DSOX3014A-03

S E R V I C E N O T E

DSOX3014A – Oscilloscope, Mixed Signal, 4 Channel,
100MHz

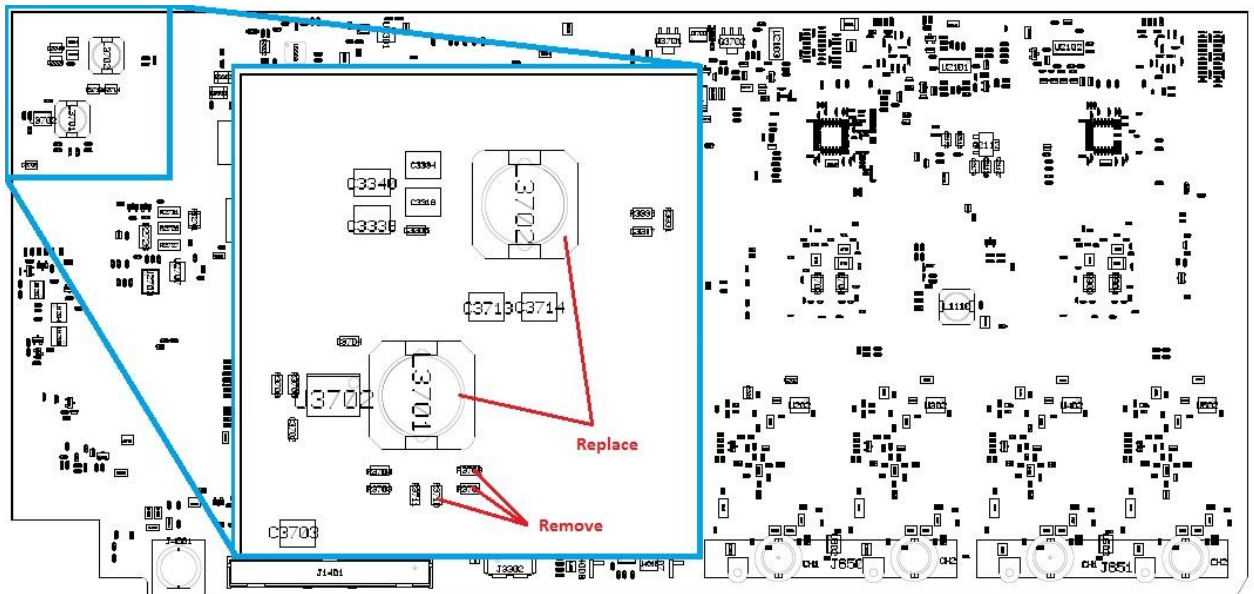
With the oscilloscope power turned on and while under normal operation, the unit emits a hissing noise.

2. As the picture indicates, remove the three resistors (0699-7209, 1 Ohm) located at R3701, R3709, and R3710. They are not to be replaced.
3. Remove as well the two inductors (9140-6474, 100uH) located at L3701 and L3702 and replace them with inductors with part number 9140-6151 (68 uH).
4. Re-assemble to the point where the unit could be powered up to verify that the hissing is indeed gone. If the hissing is not gone, please, check modifications.
5. When the hissing is gone, put oscilloscope back together.
